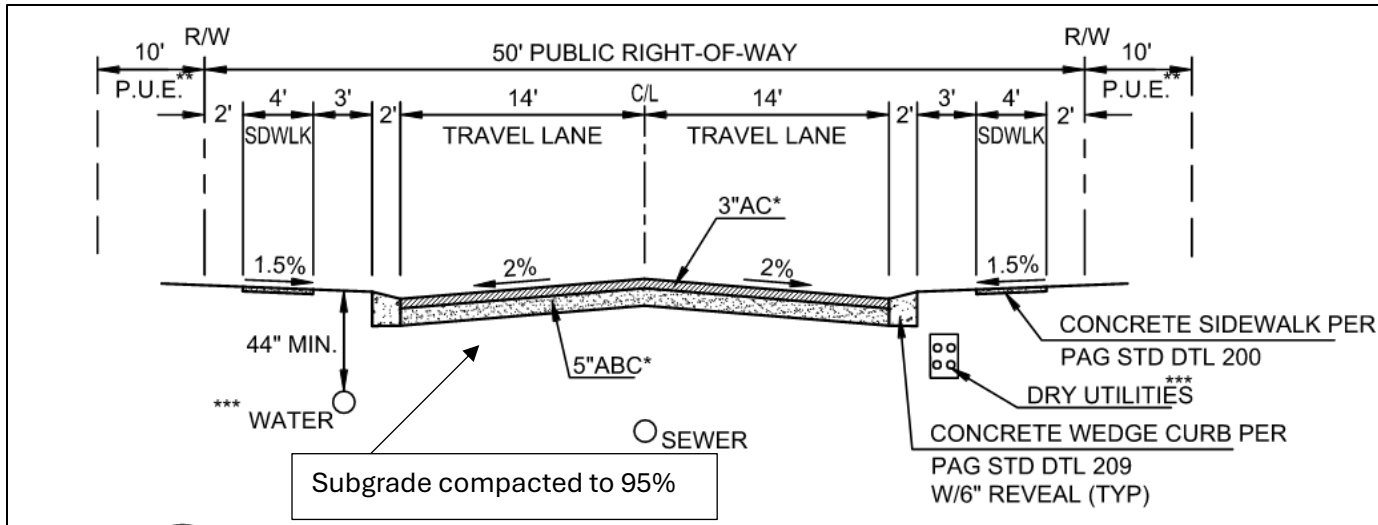
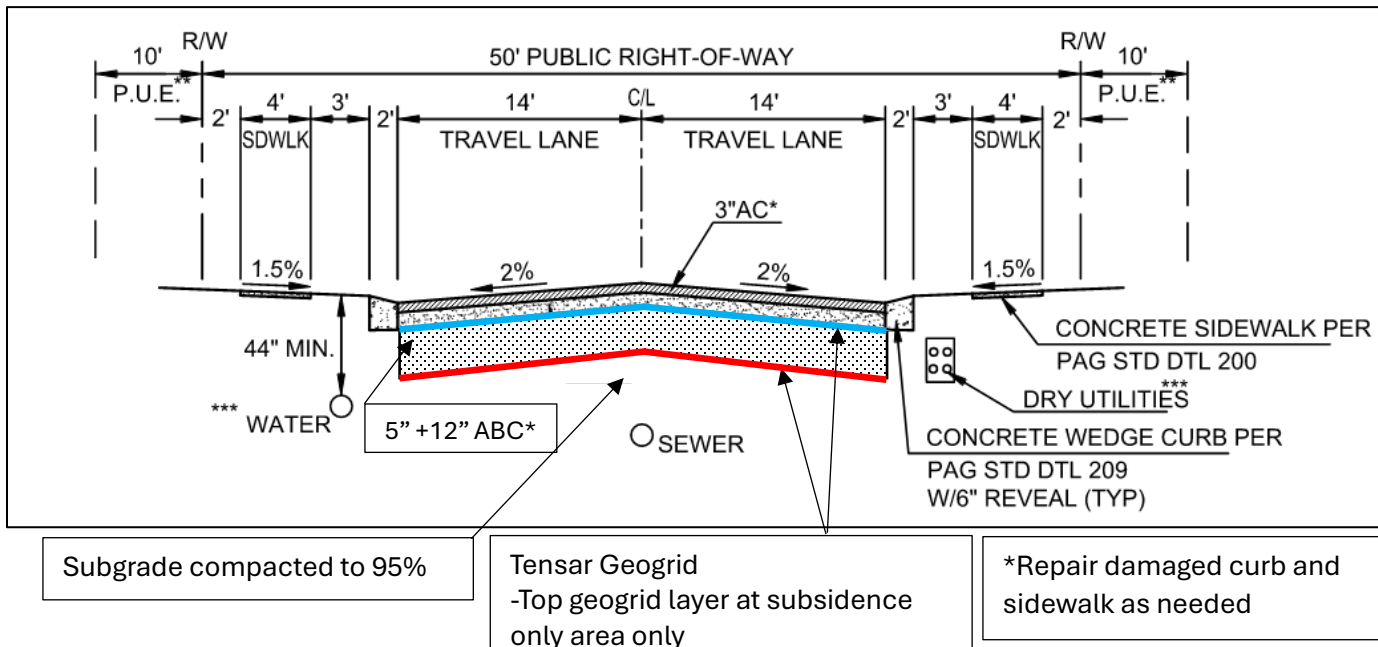
Existing "Typical" street design section per approved FLP & Public Street improvement plans by WLB

Pavement repair recommendation per Protex report dated April 18, 2024

Pulte has chosen to place an addition of a second Geogrid layer which is over and above the minimum repair recommendation within the April 18th Geotechnical Report and will create a stronger street structural section
